**PLANNING COMMISSION MEETING**  
ISD #15 District Office Building 4115 Ambassador Blvd.  
**Wednesday, April 20, 2022 at 7:00 PM**

**TO:** St. Francis Planning Commission  
**FROM:** Beth Richmond, Planner  
**SUBJECT:** Dollar General Site Plan  
**DATE:** 4-13-2022 for 4-20-2022 meeting  
**APPLICANT:** Rod Hamby  
**LOCATION:** Between Hwy 47 and Cree St NW (PID: 06-33-24-11-0070)  
**COMP PLAN:** Commercial  
**ZONING:** B-2 General Business

**ENGINEERING REVIEW  
for the City of St. Francis  
by  
Hakanson Anderson**

SHEET  
**C1**

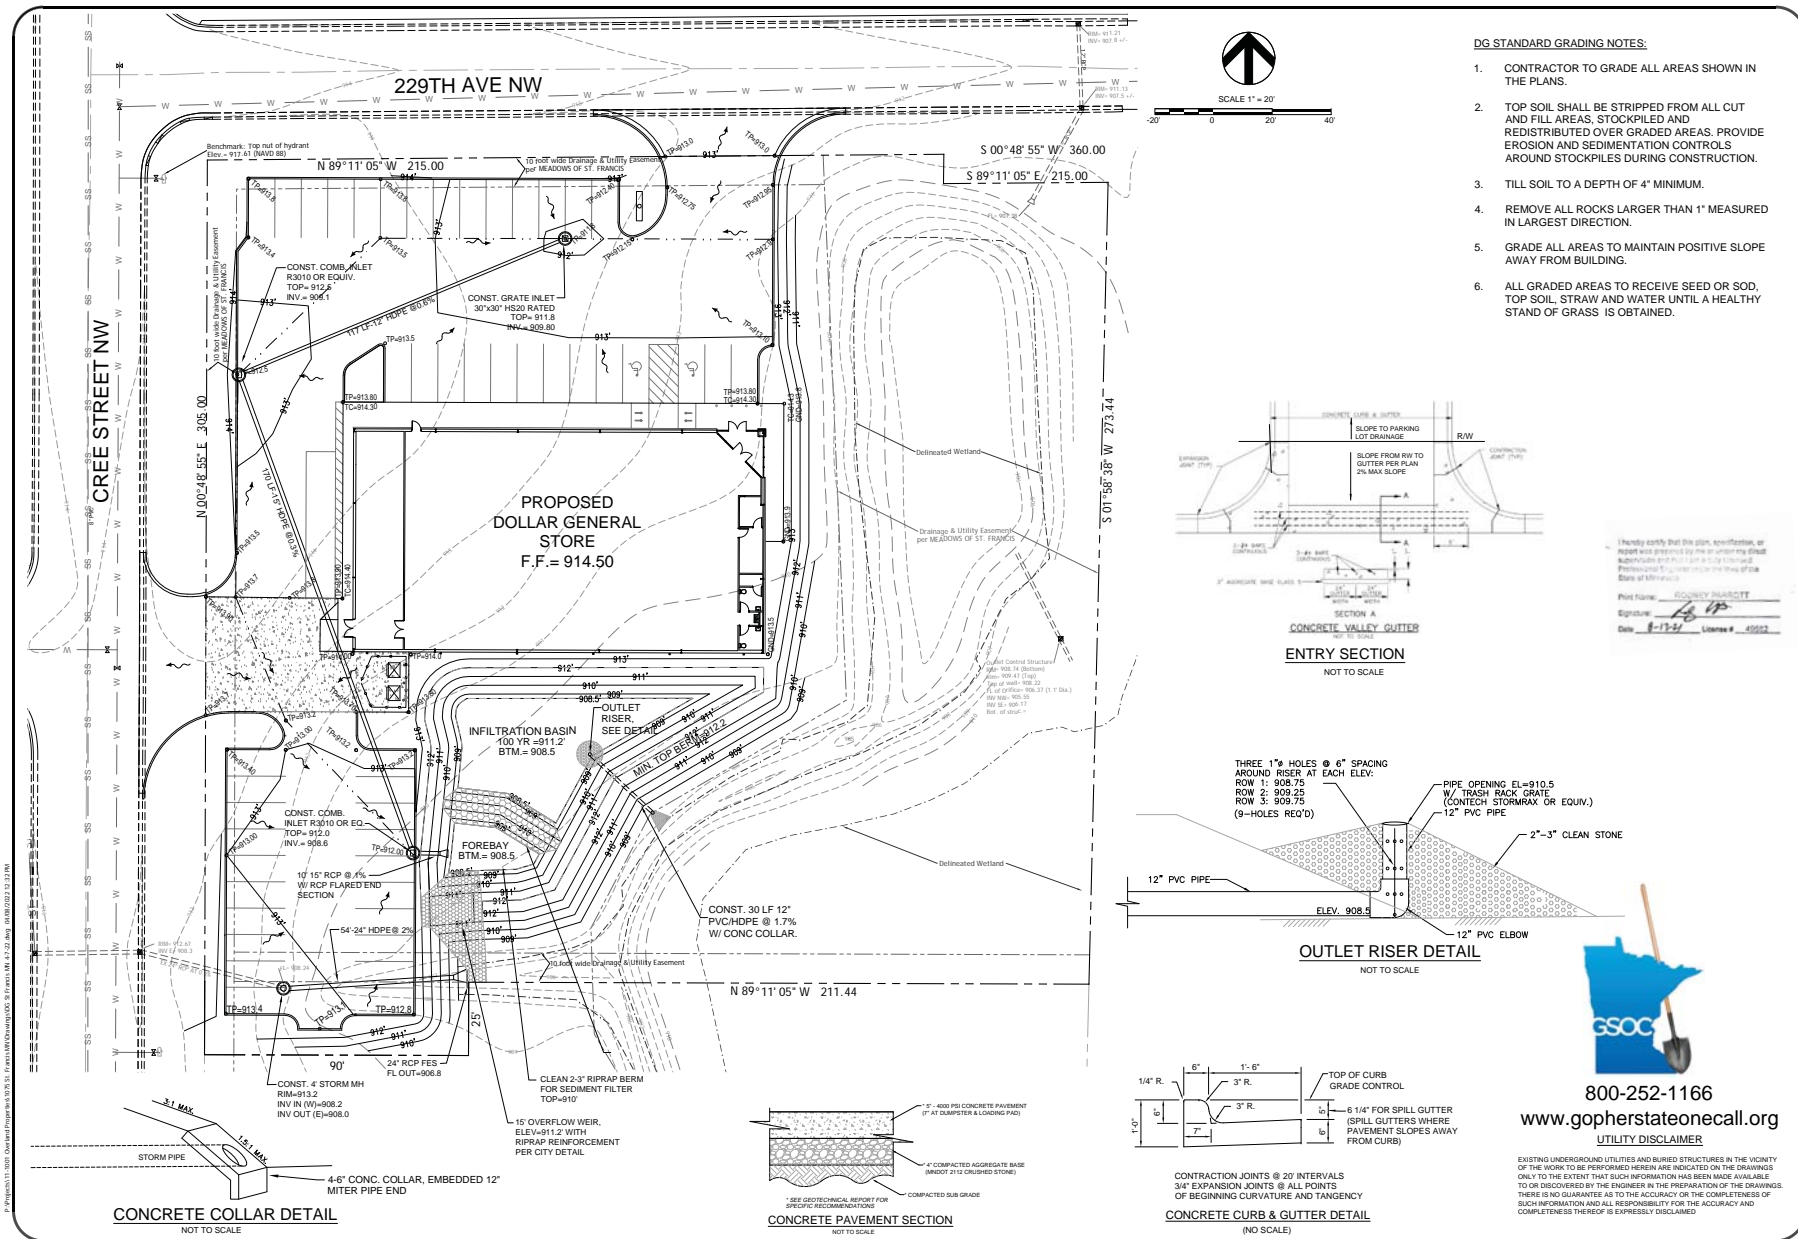
Two snow storage areas have been identified on the site plan. One is located along the easternmost edge of the northern parking lot. A second area is proposed to take up three parking spaces within the southern parking lot. While this is not something that is typically allowed, the applicant has provided documentation demonstrating that it is unlikely that all parking spaces will be used at the same time. Staff supports the proposed locations for snow storage on the site. In the event parking is needed snow may need to be and can be trucked off site.

Currently, no pedestrian connection is shown between the sidewalk around the perimeter of the building and the existing trail across the street. The applicant should work with City Staff to revise the plans to create a pedestrian connection, including a crosswalk, between the store and the existing trail.

1. Setbacks from the north and east sides of the building to the respective property lines shall be shown on the site plan.
2. All comments from MnDOT in their October 14, 2021 review letter shall be addressed.

3. At least one bike rack shall be provided near the store entrance. This bike rack shall not be placed in a way that obstructs pedestrian traffic.
4. The applicant shall enter into an encroachment agreement with the City to allow the construction of portions of the parking lot within a drainage and utility easement.

5. Snow storage is allowed on three parking spaces within the southern parking lot. In the event parking spaces are needed snow may need to be trucked off site.

11. The applicant will work with City Staff to revise the plans to create a pedestrian connection, including a crosswalk, between the building and the existing trail.

SKETCH PLAN  
FOR  
BROTHERS DEVELOPMENT

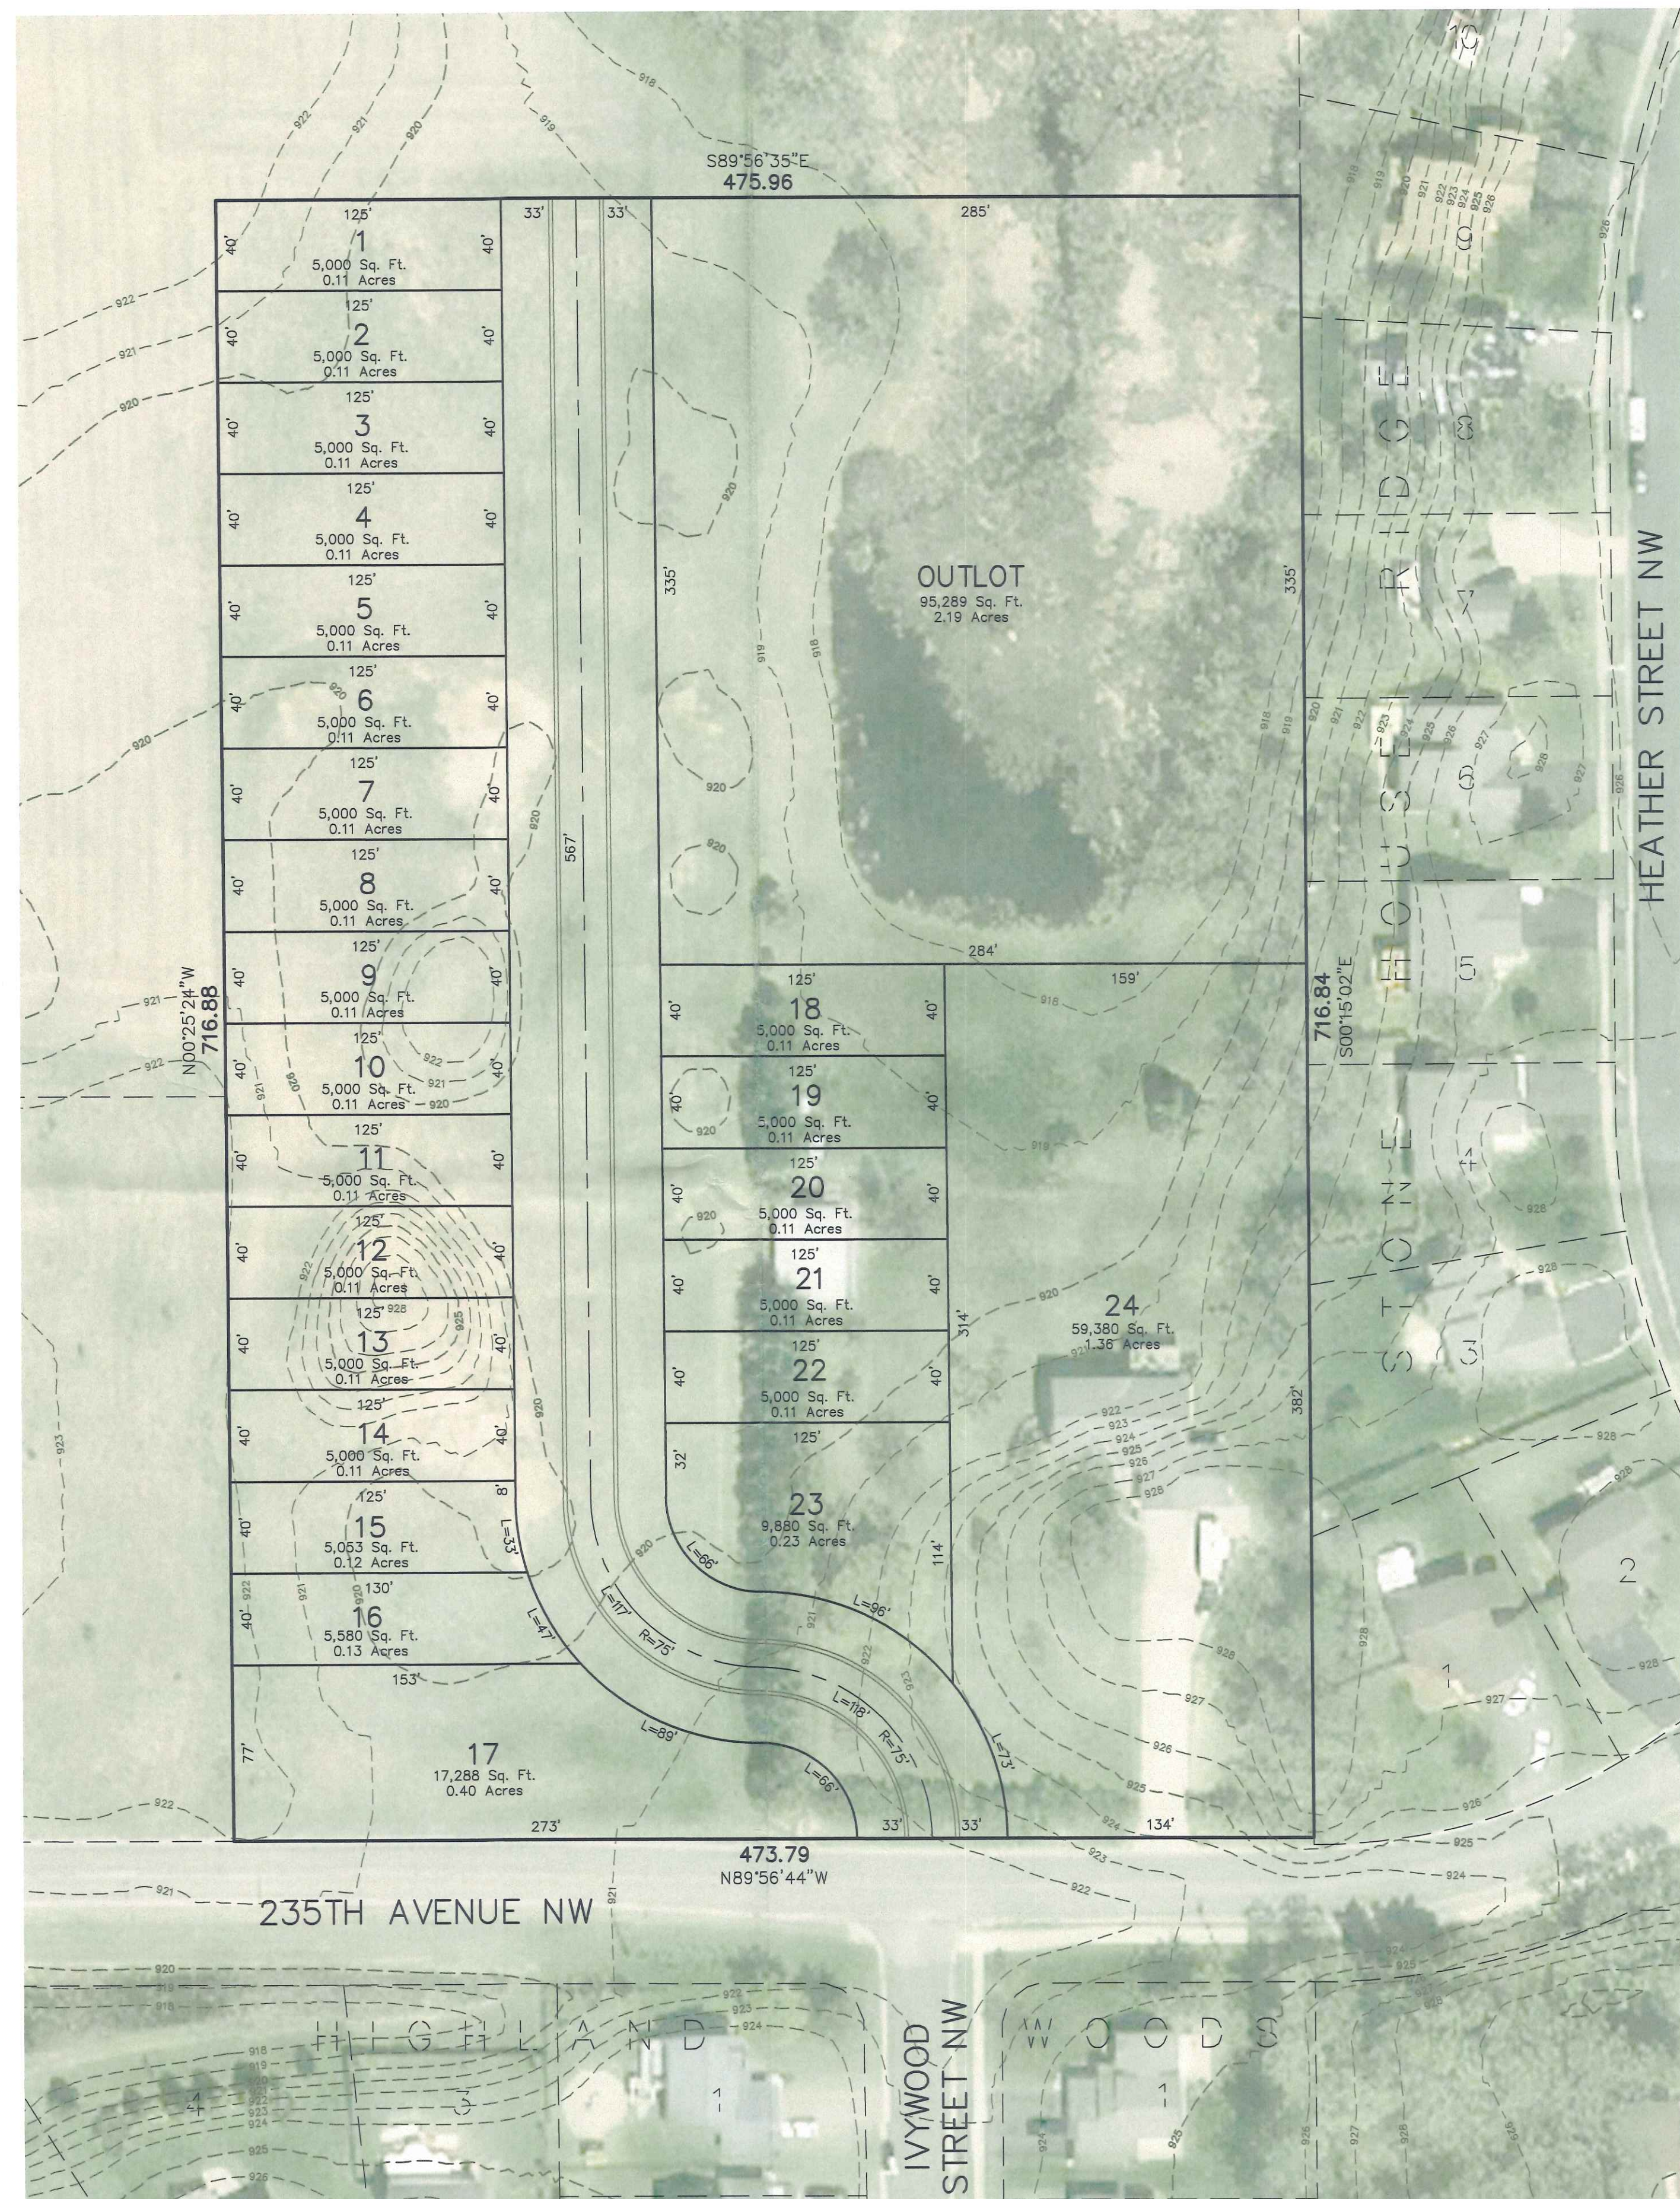
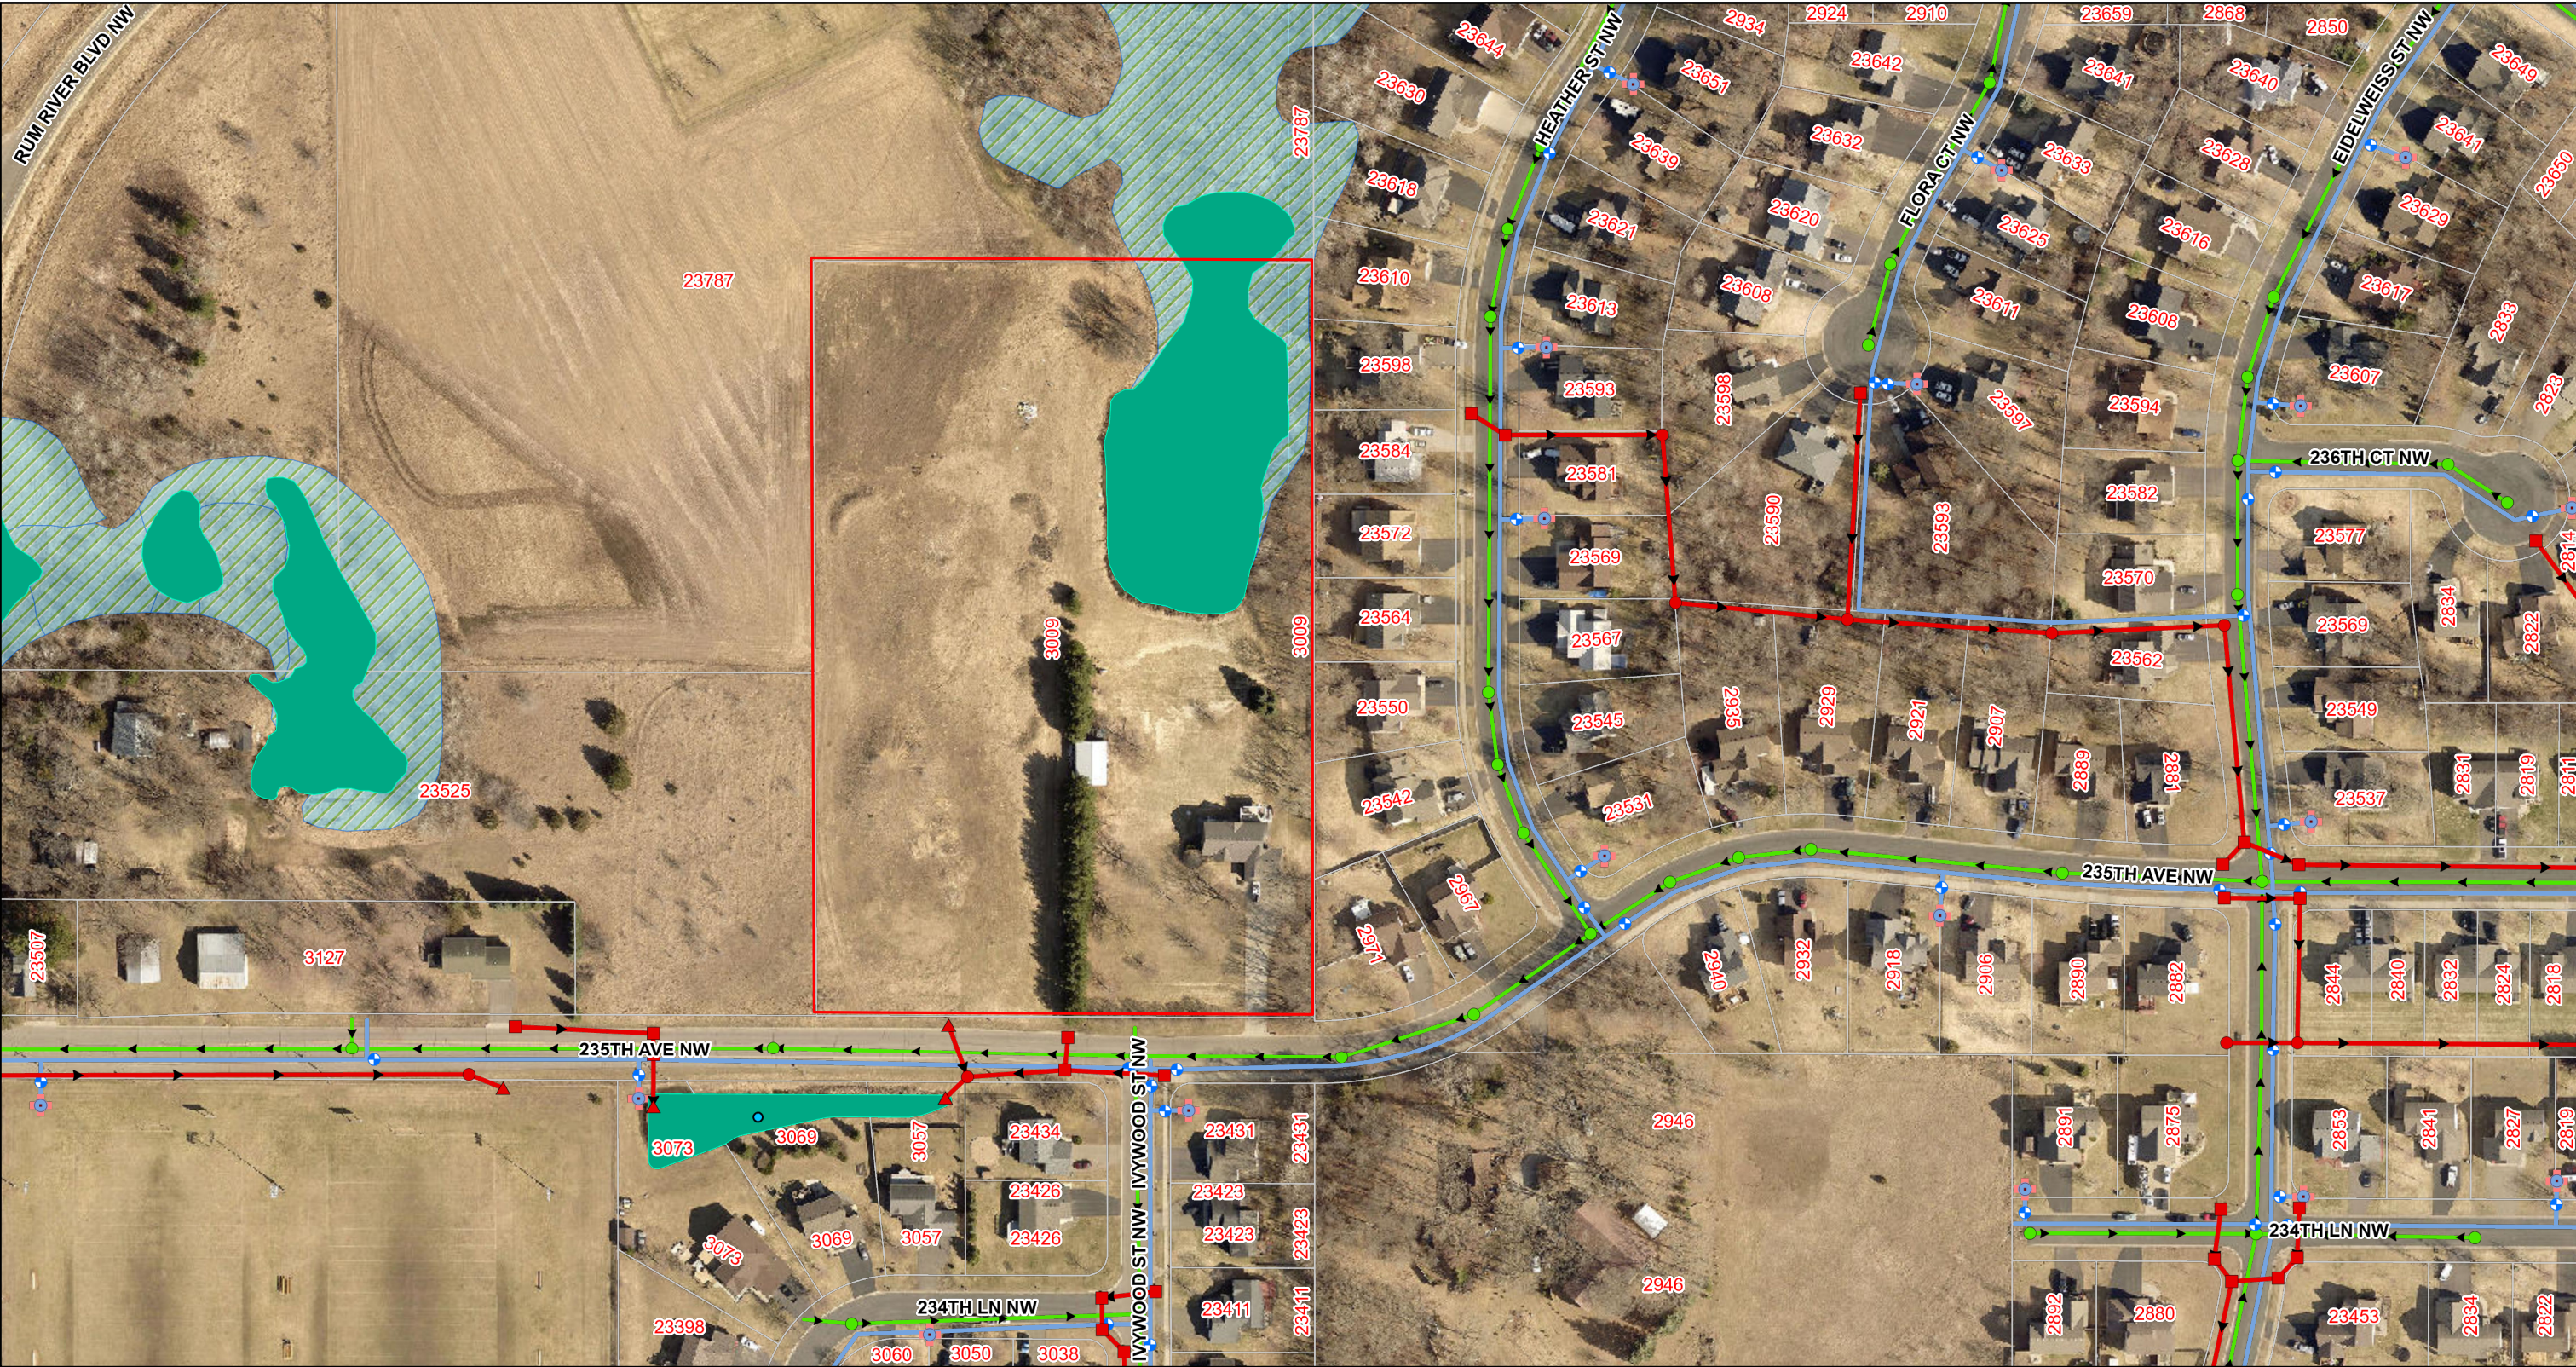
- 2040 Comprehensive Plan currently guides the subject parcel for low density residential (LDR)
  - Meant for detached single-unit homes
  - Density of 2-3 units per net acre
- Concept has proposed density of 4.3 units per net acre
- Comprehensive Plan Amendment would be needed to increase the density on the site. Amendment would likely be to reguide the area to Medium Density Residential (MDR) category
  - MDR density is 3-7 units per net acre
  - Area to the northwest is guided for MDR use
  - Land to east, west, and south is guided for LDR use
- Zoning
  - Currently zoned R-1
  - Rezoning would be required
    - Would need to rezone to be consistent with Comprehensive Plan Guidance
    - R-2 is typically the zoning district that matches the MDR land use category
  - Concept indicated that a PUD is requested to allow smaller lots and setbacks than allowed by straight zoning.

- Land Use & Zoning
  - Is a Comprehensive Plan amendment appropriate in this area?
  - If the answer to the Comprehensive Plan amendment is yes, what is the appropriate approach to zoning for the site?
    - Straight zoning to R-2
    - PUD (which is requested) – if PUD approach is used, what are the tradeoffs or public benefit for allowing deviation from dimensional standards?
    - Applicant is responsible for demonstrating value to the city in utilizing the PUD approach.
  - Proposed concept lots do not meet dimensional requirements for R-2 district

- Roadways/Access discussion points:
  - 235<sup>th</sup> Ave NW is a local road, and so no outside jurisdiction review is required to determine access
  - Existing home should access off of new public street
  - Temporary dead-end street requirements
    - Maximum density is 16 units. Concept proposes 23 units on new street.
      - Should additional street connectivity break up the dead end street?

- Build-out plan
  - Consider development in the context of the larger area and potential future development
  - Demonstrate potential future subdivision of 1.36-acre lot with existing home, including lot access

- Consider future street network
    - Consider road connection(s) to the west and north
    - Rum River Blvd NW is County road with reduced access points
